Amendments to the Drawings:

REMARKS

This response is submitted in reply to the Final Office Action mailed on August 23, 2006. Claims 1, 2 and 4-22 are pending in the patent application. Claim 19 was previously withdrawn. Claims 1, 4 and 11 have been amended. Claims 8 and 17 have been cancelled without prejudice or disclaimer. New claim 23 has been added. Additionally, replacement drawing sheets, including Figs. 2, 3, 4, 7 and 8 and the corresponding annotated drawing sheets, are submitted herewith. No new matter has been added by this response.

FIG. 2

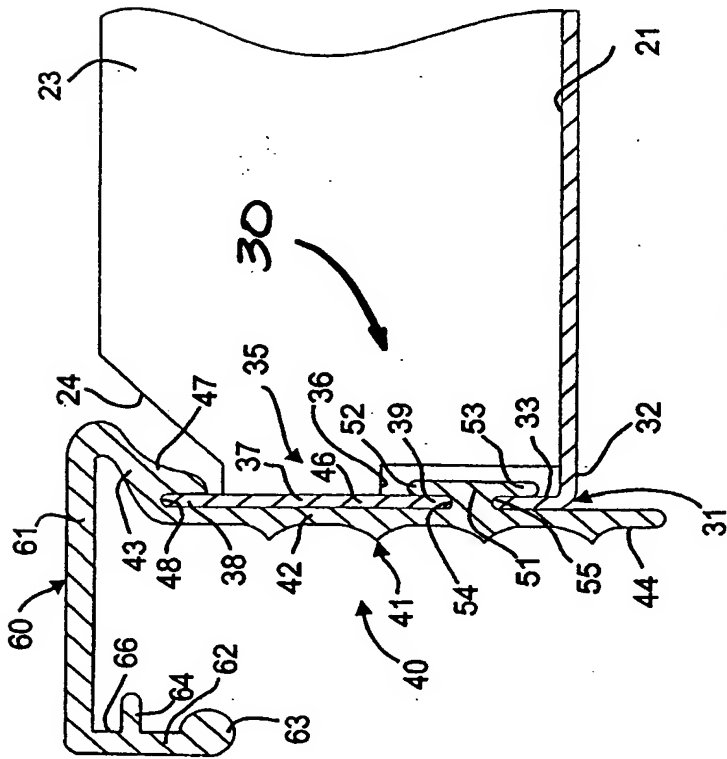
Reference number 30 and the associated lead lines were added to Figs. 2 and 3.

FIG. 7

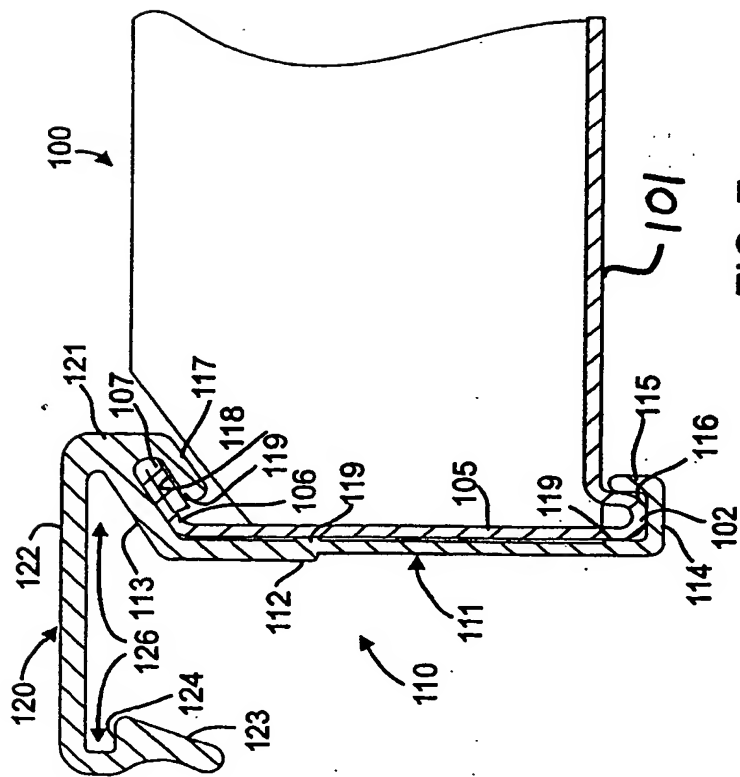
Reference number 101 and the associated lead line was added to Fig. 7.
